# UNITED STATES PATENT AND TRADEMARK OFFICE

10/568,703

<b>Office Action Summary</b>	<b>Application No.</b> 10/568,703	<b>Applicant(s)</b> BJORKHOLM, LARS	
	<b>Examiner</b> ROBIN HYLTON	<b>Art Unit</b> 3788

## DETAILED ACTION

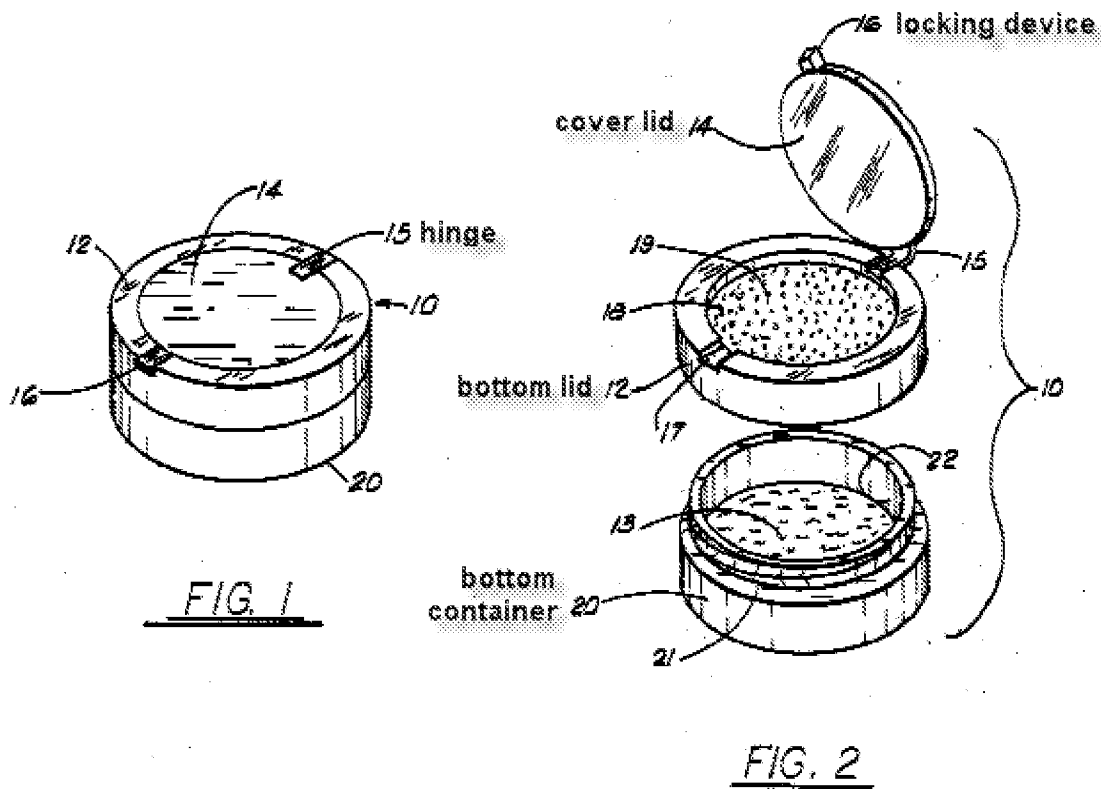
11. Claims 1,3, and 9 are rejected under 35 U.S.C. 103(a) as being unpatentable over Vetter (US 4,165,815) in view of Alexander et al. (US 6,712,076). Reference should be made to the following annotated figures of Vetter for the structural features disclosed therein.

Vetter does not disclose the hinged joint comprises pins snapped into corresponding recesses in the bottom lid. See column 2, lines 33-35 which discloses the cover lid **14** forms a tight unit with the bottom lid **12** to prevent the “leaking of the remover contained within sponge **18**” and column 2, lines 42-44 which discloses the bottom lid **12** forms a tight unit with the container (or case) **20** to “prevent escape of cosmetic product 13 from the case **20**”.
